APPLICATION NO.	FILING DATE	FIRST NAMED INVENTOR	ATTORNEY DOCKET NO.	CONFIRMATION NO.
10/684,684	10/15/2003	Kohei Yamanaka	Q76899	3402

Office Action Summary

DETAILED ACTION

FIG.2

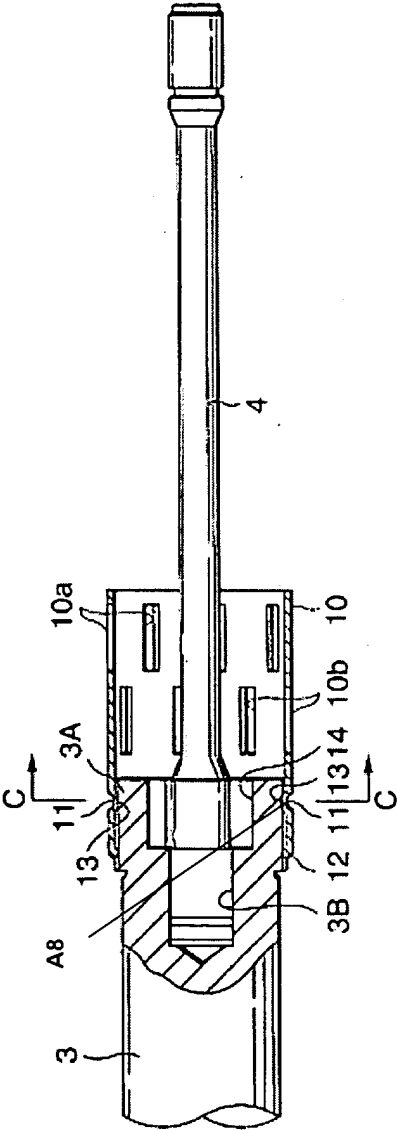
Regarding claim 1, Chikaraishi discloses, in Figures 2 and 5B, a structure comprising a shaft member **3** and a cylindrical member **10**. The shaft member **3** is formed out of a first material. The cylindrical member **10** is formed out of a second material greater in linear expansion coefficient than the first material (col. 1, lines 48-

53). The shaft member **3** has an outer periphery **A2** formed with an axial groove **11** or a circumferential groove **12**. The circumferential groove **12** has a cross-section having opposed faces **A5** substantially parallel to each other. The cylindrical member **10** is fitted to the outer periphery **A2** of the shaft member **3**. A caulked portion **11** is provided to the cylindrical member **10** at a position corresponding to the circumferential groove **12** of the shaft member **3**. The caulked portion **11** has a deformed inner surface **A8** in press contact with the faces **A5** of the circumferential groove **12**.

Regarding claim 6, the axial groove **11** comprises a plurality of groove portions in a circumferential direction.

Regarding claim 7, the groove portions are three in number.

Regarding claim 9, the cylindrical member **10** is loosely fitted to the shaft member **3** except the caulked portion **11**.

Regarding claim 11, the shaft member **3** comprises an output shaft arranged relatively rotatably with respect to an input shaft **4**.
